SALEM NUCLEAR GENERATING STATION, UNIT NO. 1

AMENDMENT TO FACILITY OPERATING LICENSE

Amendment No. 27  
License No. DPR-70

ATTACHMENT TO LICENSE AMENDMENT NO. 27

FIGURE 6.2.1. OFFSITE ORGANIZATION FOR FACILITY MANAGEMENT AND TECHNICAL SUPPORT

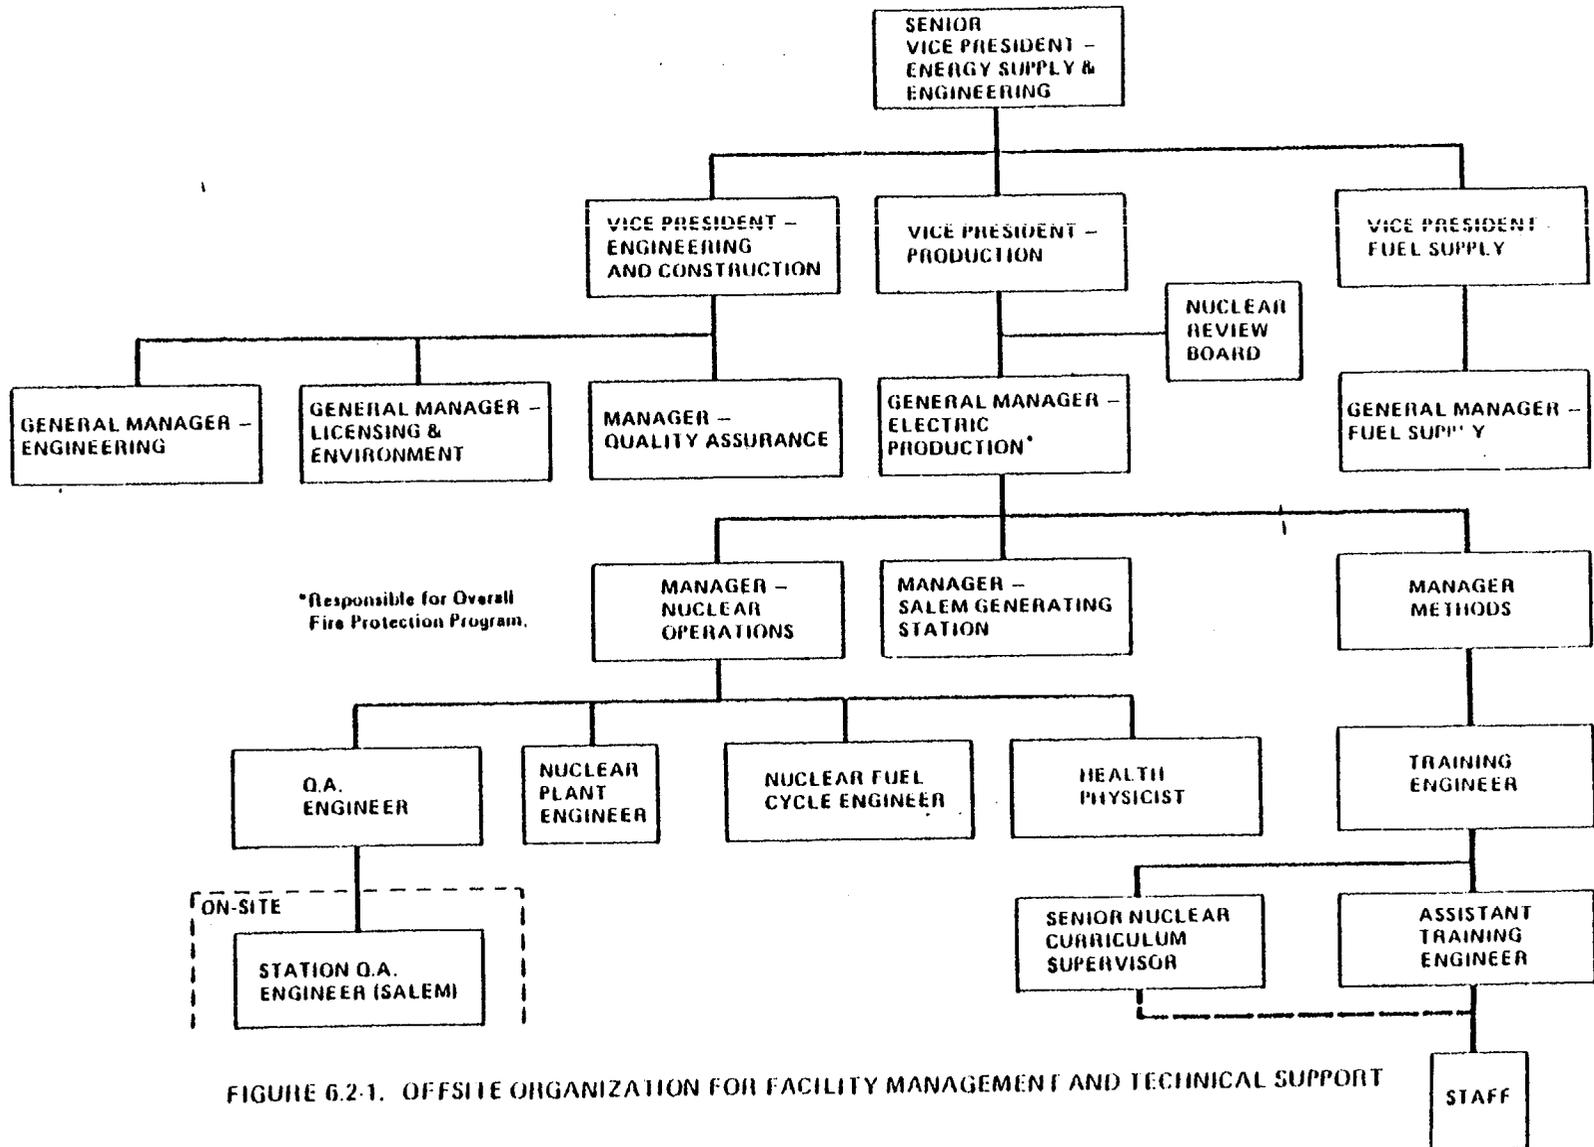
6.2.1 The offsite organization for facility management and technical support shall be as shown on Figure 6.2-1.
